REMARKS/ARGUMENTS

Applic. No.: 10/715,069
Amdt. Dated January 5, 2005
Reply to Office action of August 5, 2004

Fig. 2

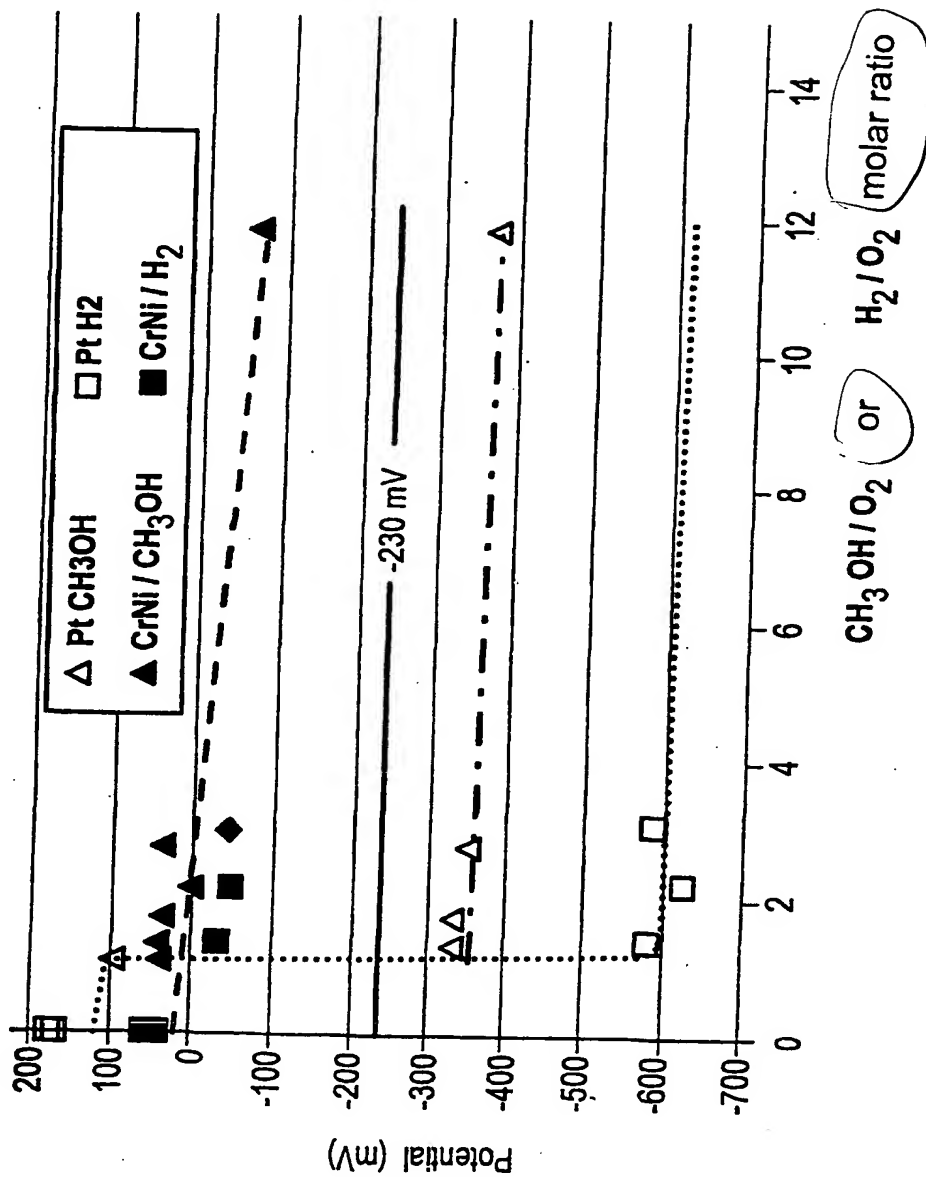
More specifically, the Examiner has stated that in Fig. 2 abscissa units are missing. Fig. 2 has been amended to clearly show the abscissa unit.

The attached sheet 2/2 of drawings includes changes to Fig. 2.
This sheet replaces the original sheet 2/2. In Fig. 2, the
abscissa has been clarified.
